ERRATA PAGES

Attached please find corrected replacement pages for the Application and Supporting Environmental Report for USNRC Commercial Source Material License. Please replace the original pages with the corrected pages.

REV.	FERRET OF NEBRASKA, INC.		
DATE			
	CROW BUTTE PROJECT		
	Dawes County, Nebraska		
	ENGLISH CREEK AND		
	SQUAW CREEK WATERCOURSES		
	PREPARED BY: F.E.N.		
	DWN BY: JC	DATE: 8/87	FIGURE: 2.7-1

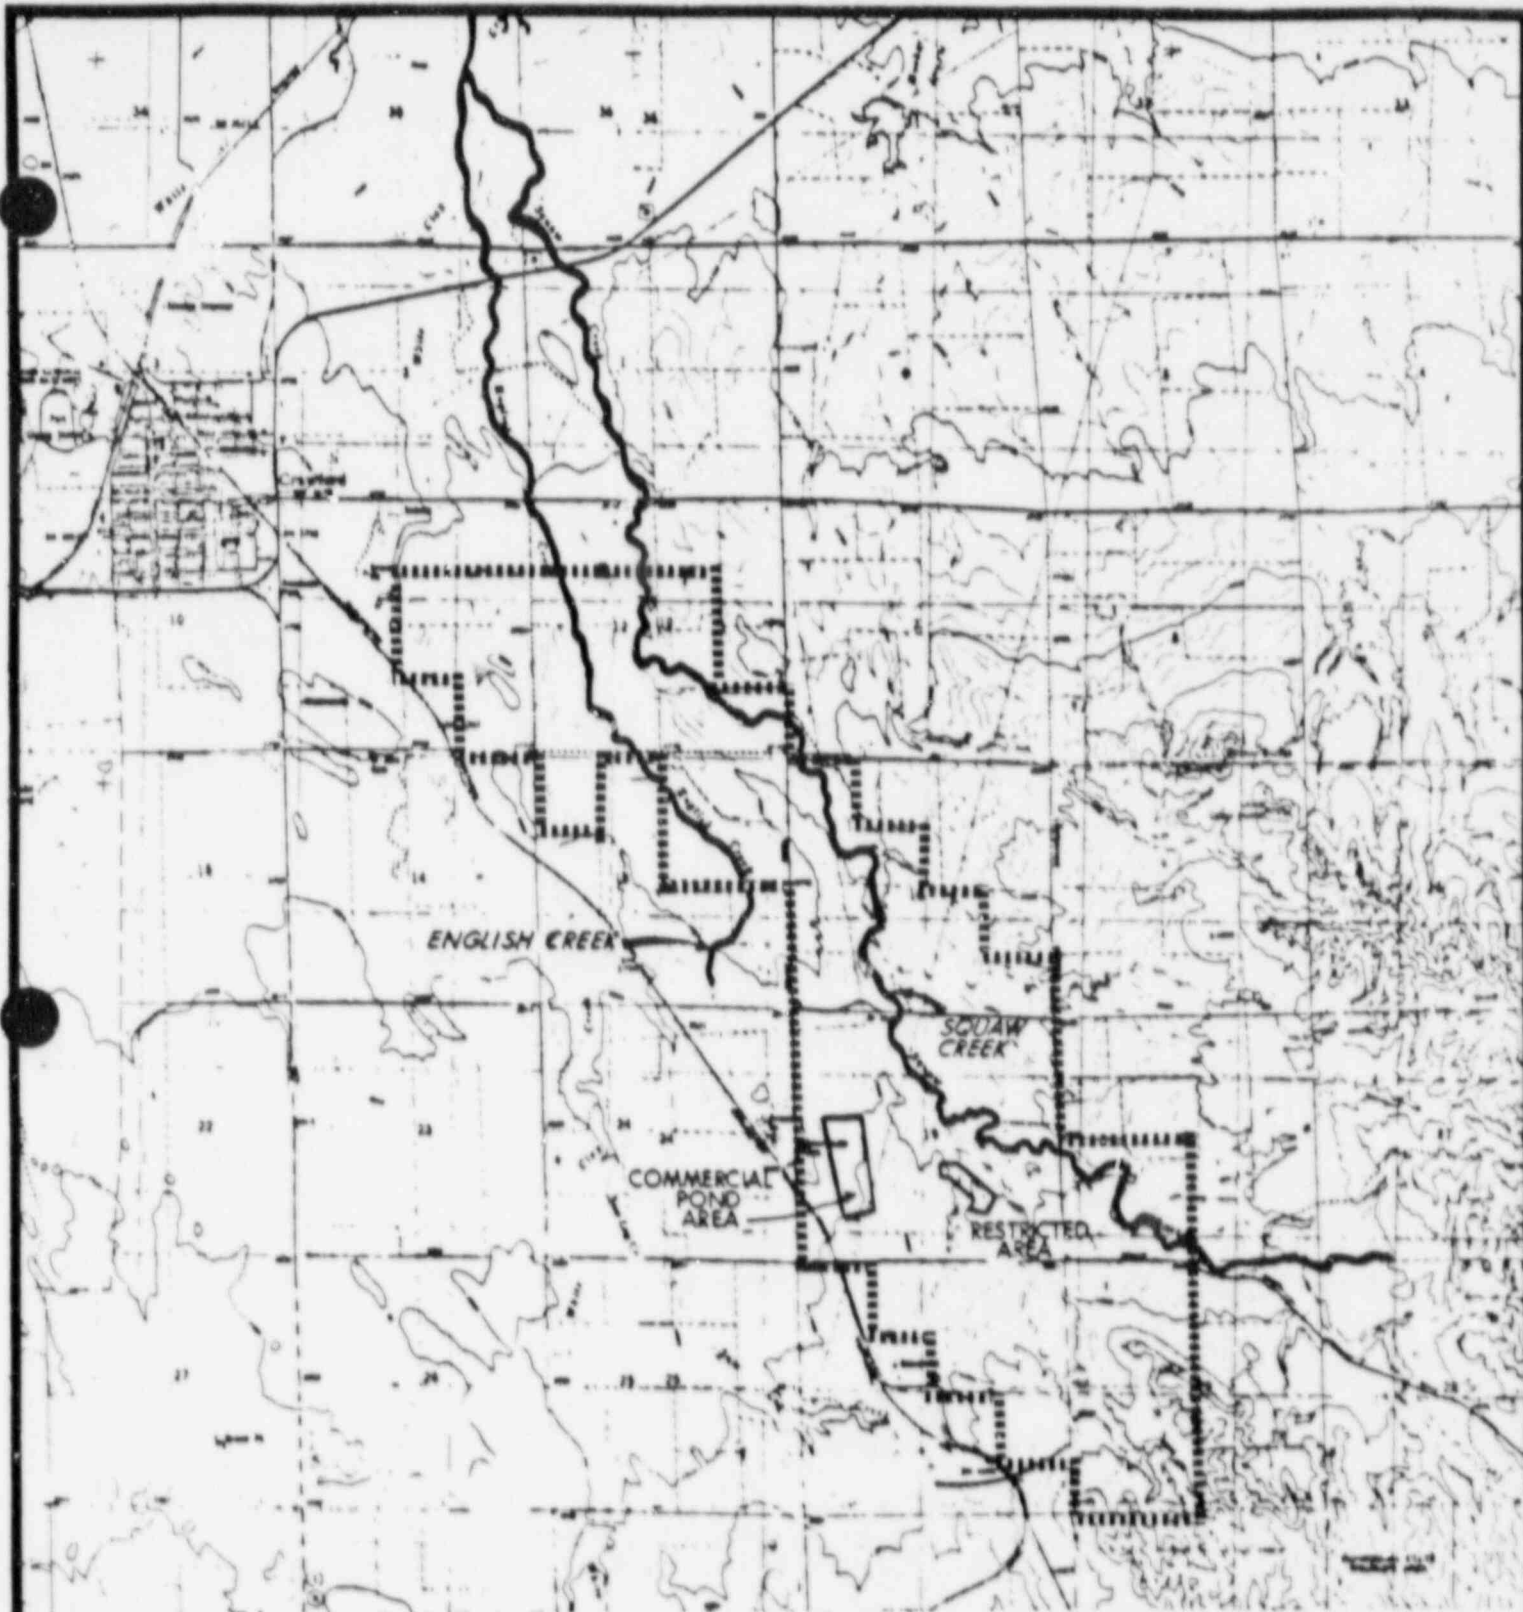
<u>Page No.</u>	<u>Change</u>
2.7(3)	Figure 2.7-1 was modified to correct the point at which English Creek originates.
2.7A(26)	Added the partial sentence "approximately 1.4% of the overall flow produced during the pumping". This partial sentence was inadvertently deleted. The defined units for Equation 6 were also corrected.
